57 & 57A Schnapper Rock Road Plan Change

Transportation Assessment

Private Plan Change

Transport RFI response

Figure 2.2 Potential access locations and westbound lane sight distance (100m)

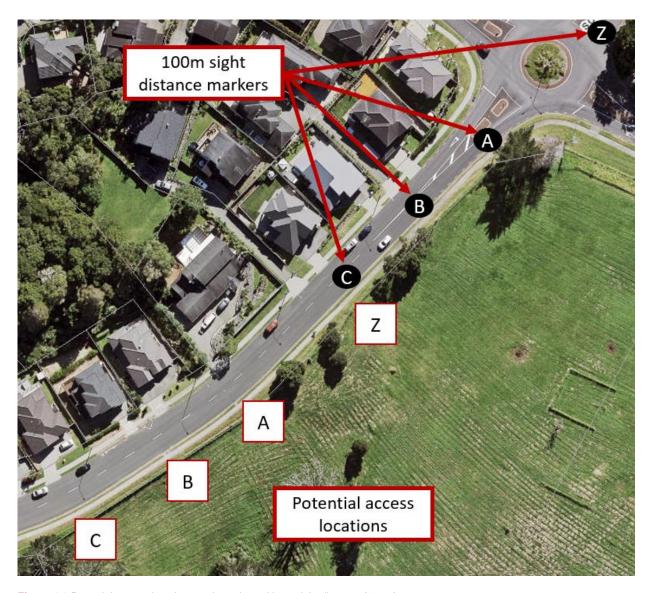
Provide information about the sight distances available at the proposed intersection location and the operating speed of traffic at that location.

We have considered how 107m (eastbound) and 100m (westbound) sight distance would look for various potential access locations along the site's frontage. We have used four potential access locations as case studies. Location A is the access point indicated in concept plans, with locations B and C further west along Schnapper Rock Road. Location Z has been considered as an alternative nearer to the Oakway Drive intersection. These four locations and the sight distance along the westbound lane (100m) are shown in Figure 2.2. These sight distance measurements have been measured from aerial photography, noting from our site visit that the gentle downgrade does not present any challenges for vertical sightlines (such as a crest) from either direction.

The assessment of sight distance for the westbound lane to a potential access point (Z, A, B or C) shows that SISD would not be plausible for an access point at location Z however given the relatively straight alignment (and lack of vertical crests) along this section of Schnapper Rock Road, there is adequate sight distance for the westbound lane for locations A, B and C. Generally, we consider that any location 100m or further away from the roundabout limit line has adequate sight distance for the westbound lane.

Figure 3.1 Morning peak development trip distribution at Albany Hwy

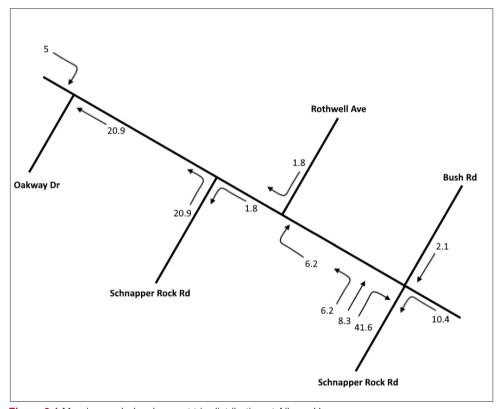
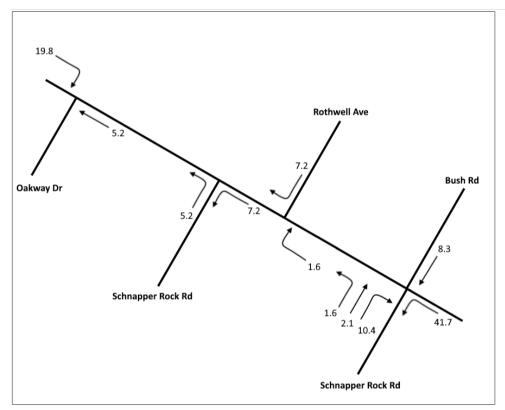
Provide a rationale for the adopted trip assignment, or provide an updated assignment.

The additional morning and evening peak trips occurring due to the development are shown in Figure 3.1 and Figure 3.2 for the key intersections with Albany Highway.

Figure 5.1 2021 intersection configuration at Albany Highway / Oakway Dr

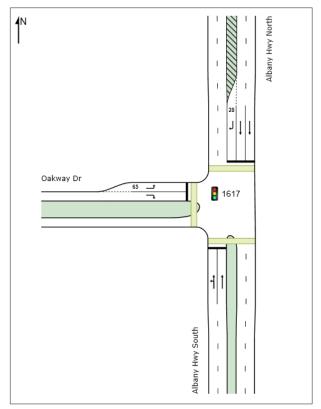
Provide an assessment of the Oakway Drive / Albany Highway intersection.

The operation of this intersection is not described. The assessment does not provide any data to inform an assessment including if this intersection has any issues (such as poor LOS, high delay, extensive queueing) for the existing or future expected (e.g. 2030) traffic conditions.

SIDRA modelling for this intersection has been undertaken, utilising the SCATS detector flows obtained for 12 – 18 April 2021. Lanes were configured as currently installed, including T2 lanes along Albany Highway to the north and south. The layout used in the 2021 modelling is shown in **Figure 5.1**, note that the western approach is currently disabled in SCATS as the property utilising it is unoccupied.

Using the SCATS phasing provided by ATOC, the SIDRA results show that the performance of the intersection in the peak periods is busy, but not overly congested. The overall level of service is LOS C in both periods, queues generally contained within available capacity, and a worst movement degree of saturation of 0.531 in the morning peak and 0.765 in the evening peak.
